CONSTRUCTION SUMMARY

Mayfield Village 2 (G) - Minnisale Homes Corp.

LOT / PHASE	REG. PLAN #	HOUSE TYPE		
16 / 2	43M-2060	Millwood 2 Elev 2

Revised Kitchen Layout

Lot 16
Minnisale

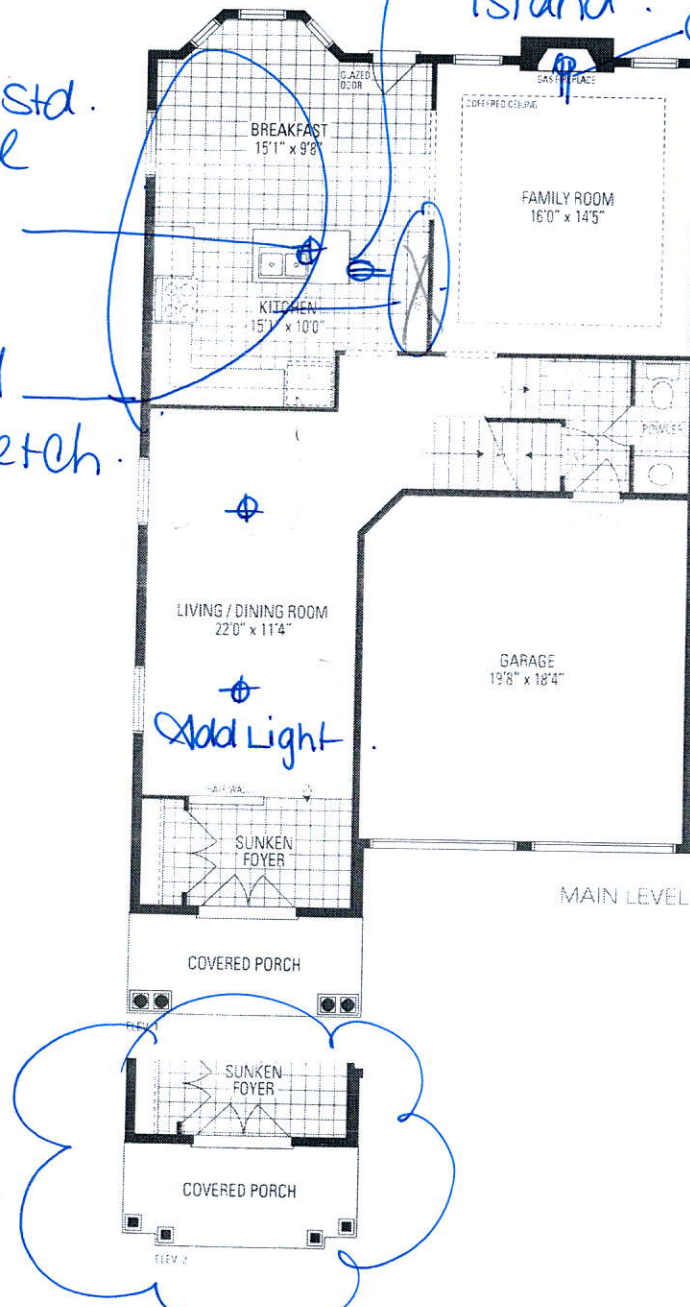
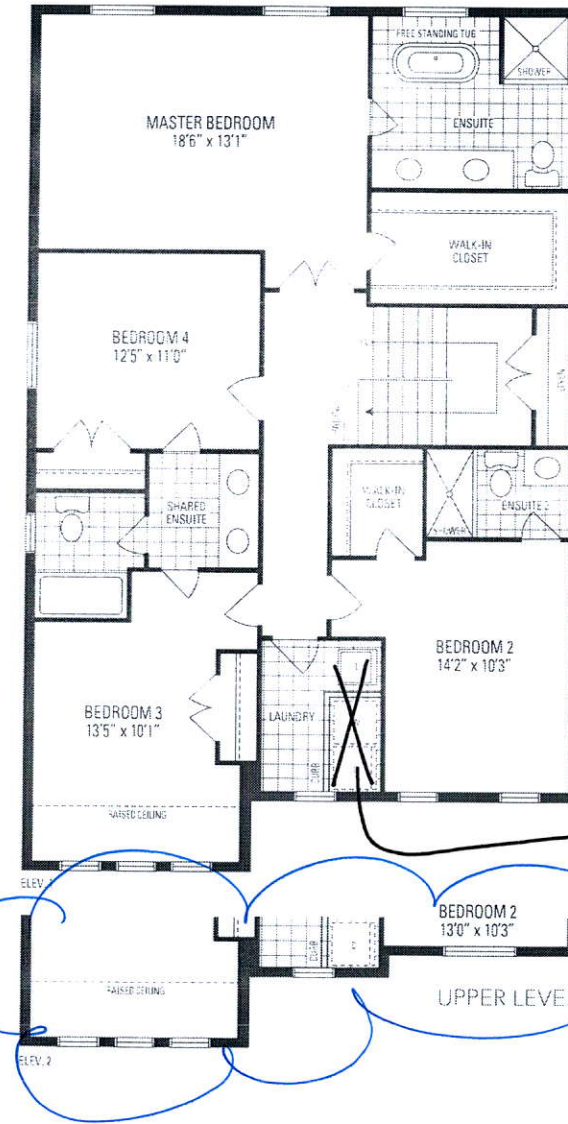
Relocate Std.
Light Above
Island.

Revised
See Sketch.

Add Plug to
Island.

Add Plug.

Add Window

Enlarge All
Basement
Windows.

Laundry
Relocated
to Basement.

MAIN LEVEL

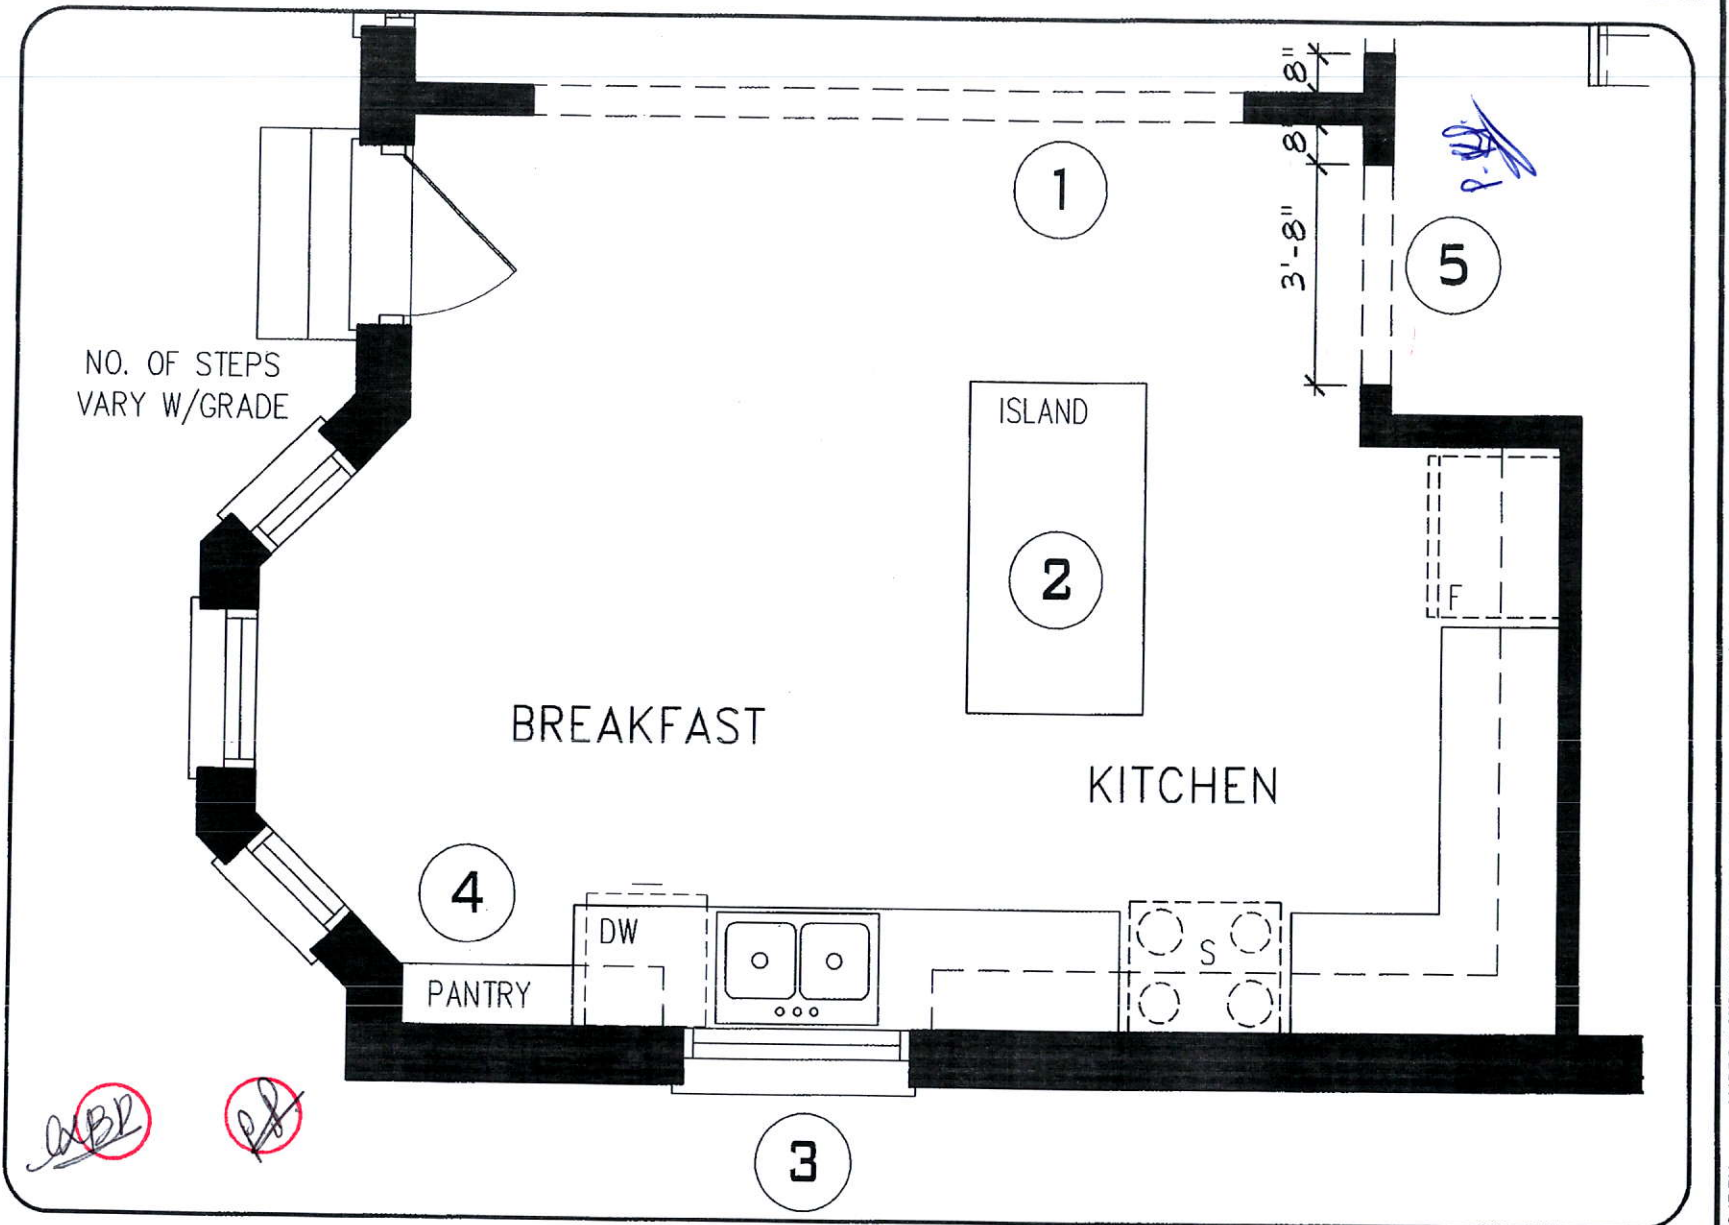
1. INCREASE ARCHWAY TO 12'-0" WIDTH BETWEEN ROOMS.
2. RELOCATE SINK AND DISHWASHER TO OUTSIDE WALL. EXTEND COUNTER AND CABINETS 6'-6".
3. SHIFT WINDOW 2'-0" TOWARD FRONT OF HOUSE AND REDUCE WINDOW HEIGHT TO APPROX. 4'-0".
4. RELOCATE PANTRY.
5. INCREASE KITCHEN ARCHWAY AND MAKE EQUAL RETURNS AS FAMILY ROOM SIDE.

LOWER LEVEL

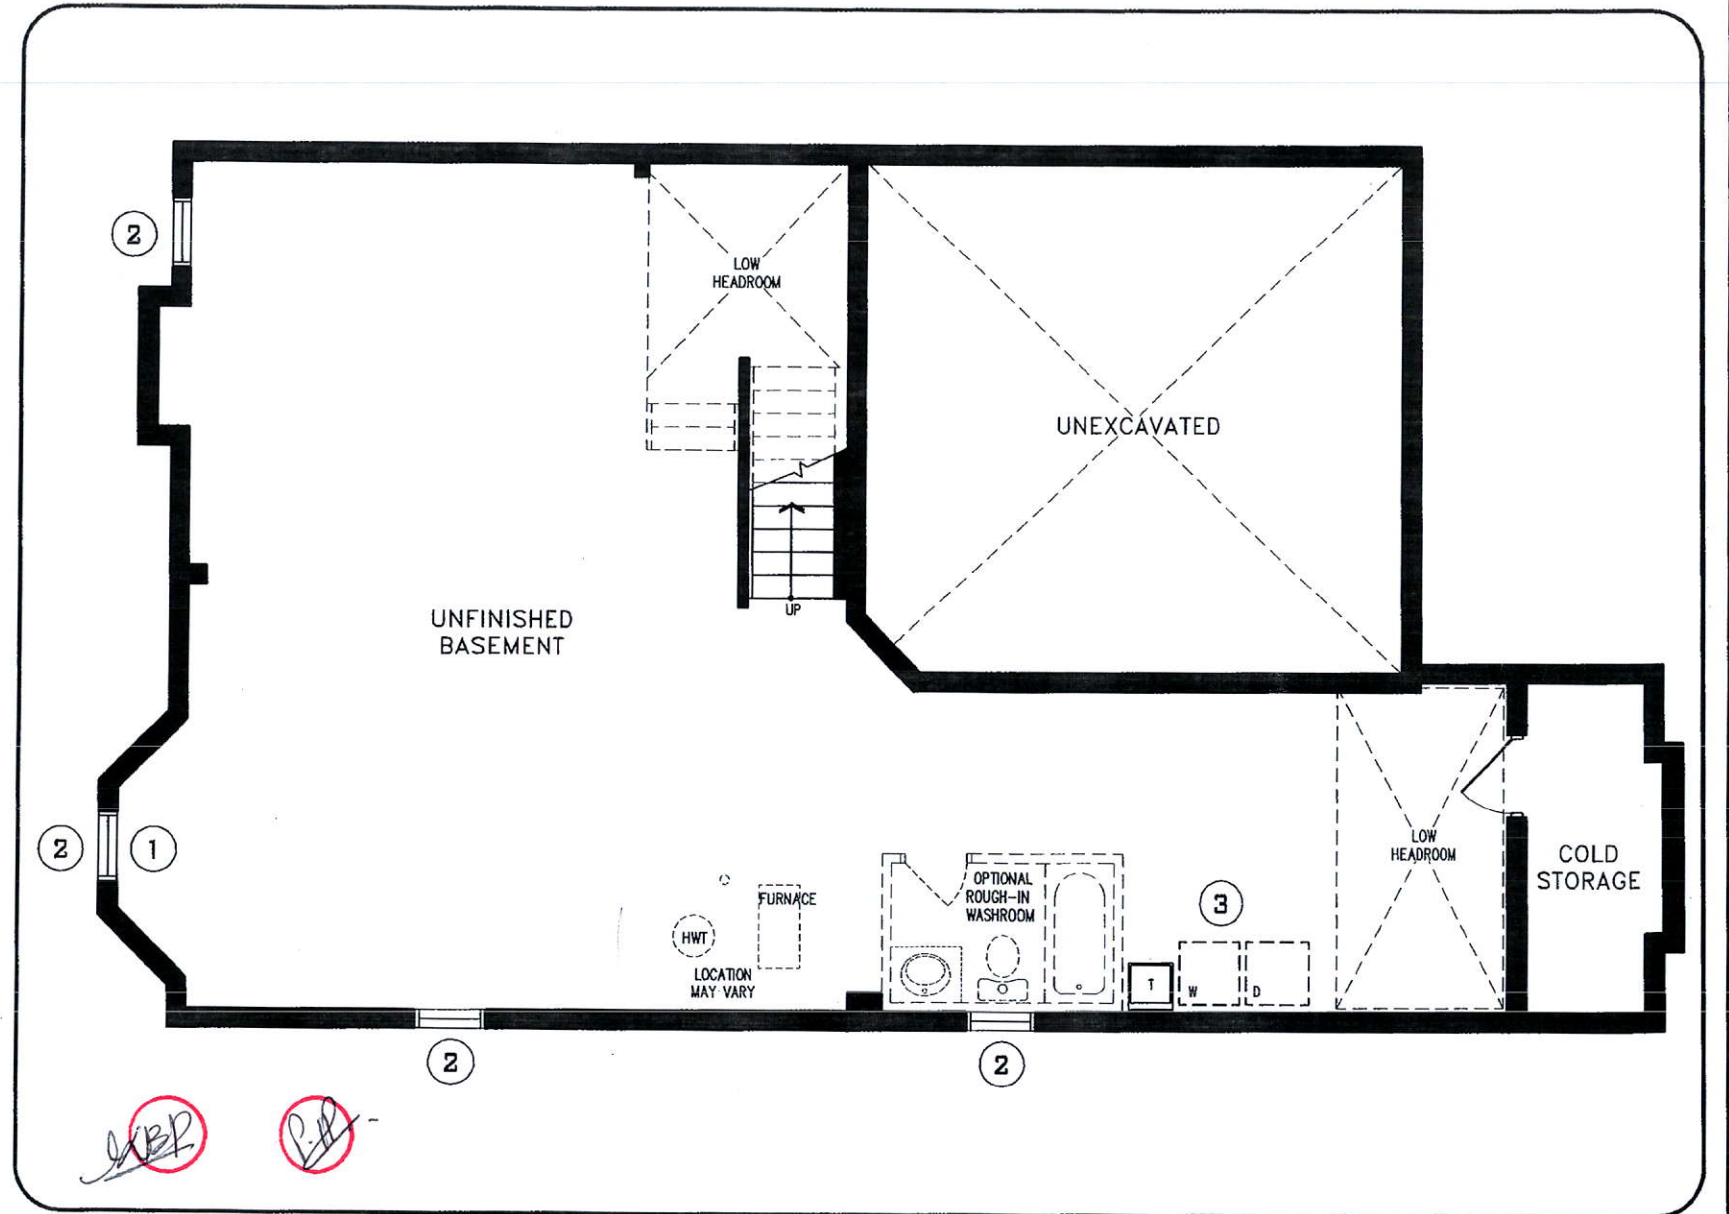
1. ADD BASEMENT WINDOW TO REAR BAY AREA.
2. INCREASE ALL BASEMENT WINDOWS TO 30"X24" SIZE.
3. ADD LAUNDRY TUB AND ROUGH-IN FOR FUTURE WASHER/DRYER.

③ Move Laundry to Basement
